C-E Power Systems
Combustion Engineering, Inc.
1000 Prospect Hill Road
Windsor, Connecticut 06095

License SNM-1067
Docket 70-1100

June 1, 1981

Reference: Letter from Mr. H. V. Lichtenberger to Mr. R. G. Page, dated
March 18, 1981; Amendment Application - Pellet Storage Shelves

FIGURE D-1.6.1

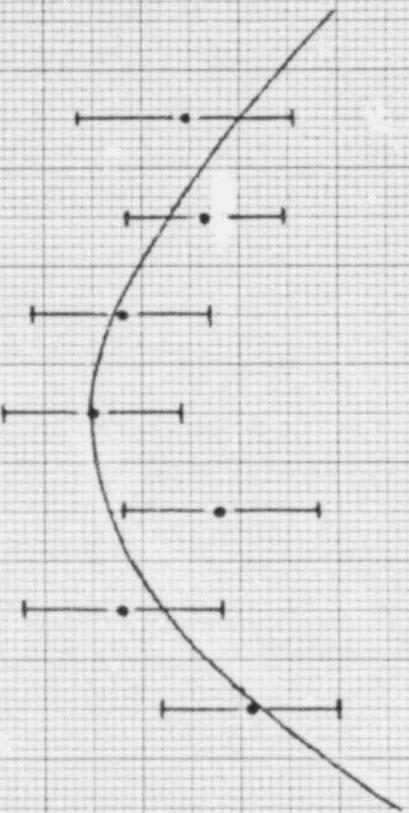
In response to comments made to our amendment application referenced above by
Mr. N. Ketzlach of your staff, we are hereby submitting the attached as a sup-
plement to the original application.

The additional criticality analysis plus the resolution of other comments are
submitted for your approval in the following page changes:

The following conservative assumptions were incorporated into the calculational model of the pellet storage shelves:

- 1) Each shelf was assumed to hold a 4.0 inch thickness of UO₂ at optimum moderation and maximum enrichment (4.1 wt.% U²³⁵).
- 2) The system was assumed to be infinite in the horizontal plane.
- 3) Variable density external water mist was introduced to determine peak reactivity.

The KENO-IV Code with 16 group Hansen-Roach cross sections was used to determine the reactivity of the pellet storage shelves under various conditions of moderation. Optimum moderation of the fuel occurred at a concentration of 2.4 gm U/cc in water, assuming no external water mist. The peak reactivity

- * of the system, $K_{eff} = 0.9313 \pm 0.0044$ occurred at an external water mist
- * density of 0.025 gm/cc which is higher than one could attain from fire fighting equipment or a sprinkler system. The criticality safety analysis demonstrates that the spacing boundary can be located 60 inches from the front of the shelves.
